PROPOSED MINING ON A PORTION OF THE REMAINING EXTENT OF THE FARM ELANDS SPRUIT NO 5523, ALFRED DUMA MUNICIPAL AREA KWA-ZULU NATAL PROVINCE

COMMENTS AND RESPONSE REPORT

REF NO: KZN 30/5/1/3/2/10817 MP

FEBRUARY 2023

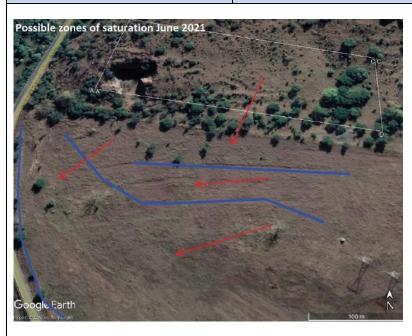
- 24. The wetland specialist determines that the bulk of the study area comprises a "temporary (outer) zone of a wetland, according to the terminology used in the DWAF (2005) wetland delineation manual." We have included (below) two (2) Google Earth images of January 2017 and June 2021 respectively, clearly indicating saturated zones far exceeding the boundaries of their Figure 18 presented as the Hillslope Seepage wetland.
